**Re: 703-723 W. Algonquin Rd – PUD Amendment – Amendment to PUD Ordinance 18-014 PC#20-016
– Round 3**

The following is our Planning Commission response Letter addressing the comments as outlined in the Village of Arlington Heights Building & Life Safety Department Interoffice Memorandum regarding the aforementioned project:

Planning & Community Development Dept. Review Round 2 Comments

Exhibit E

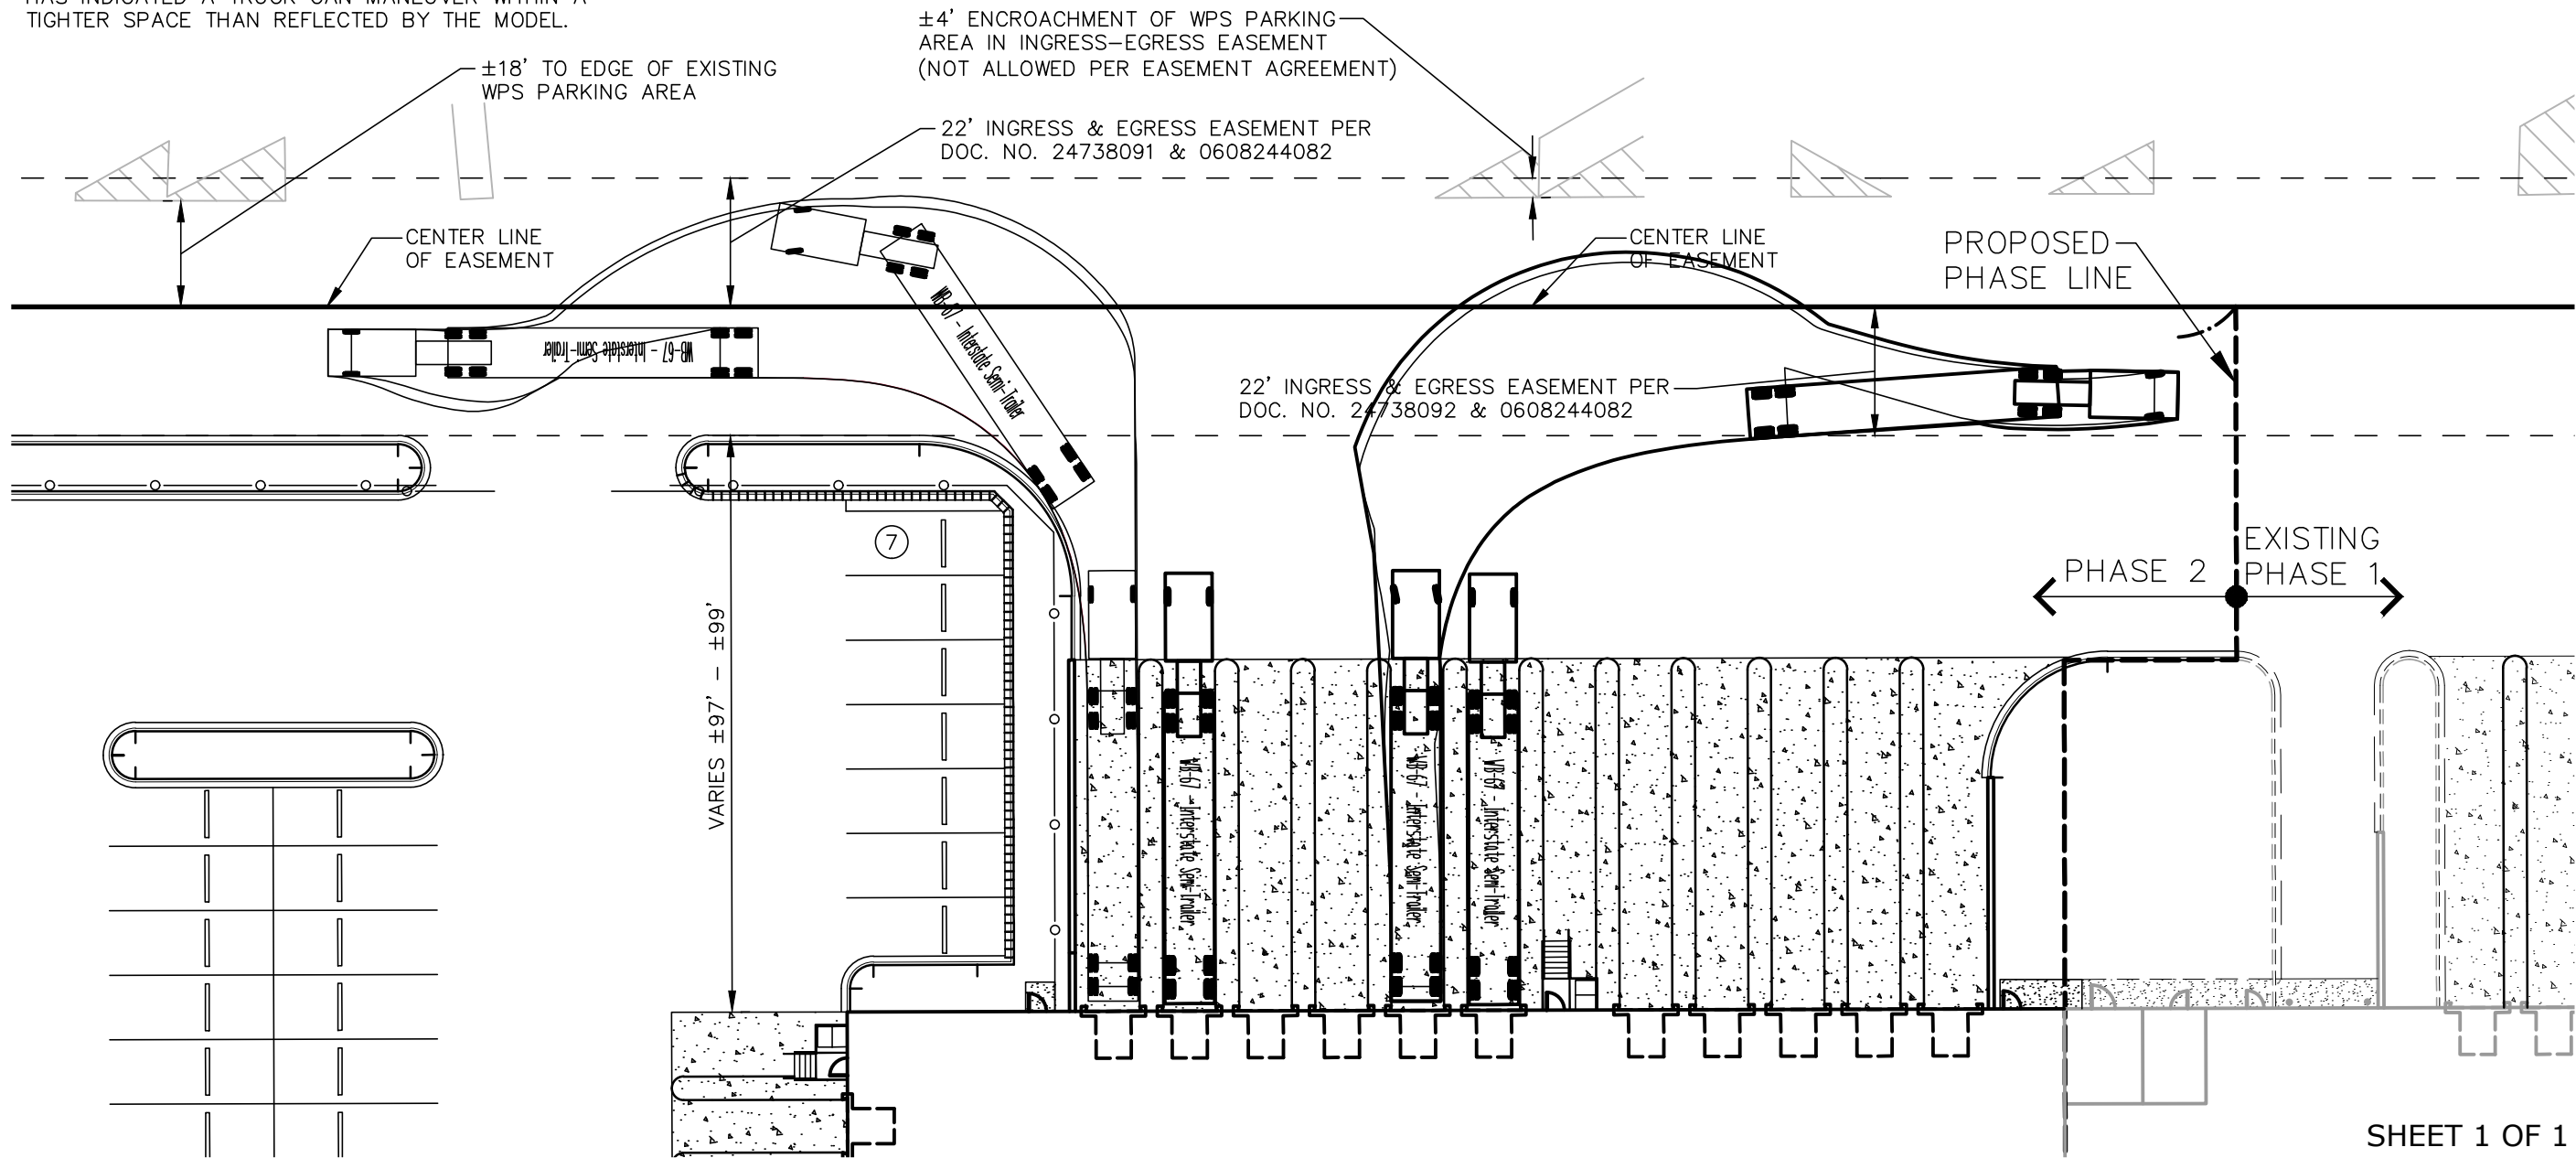
43. **Response:** Noted: See Truck Routing/Turning plan (Exhibit E). Plan shows requested information for the southernmost truck dock. Also includes ingress and egress info while truck and trailer is parked in the adjacent space.
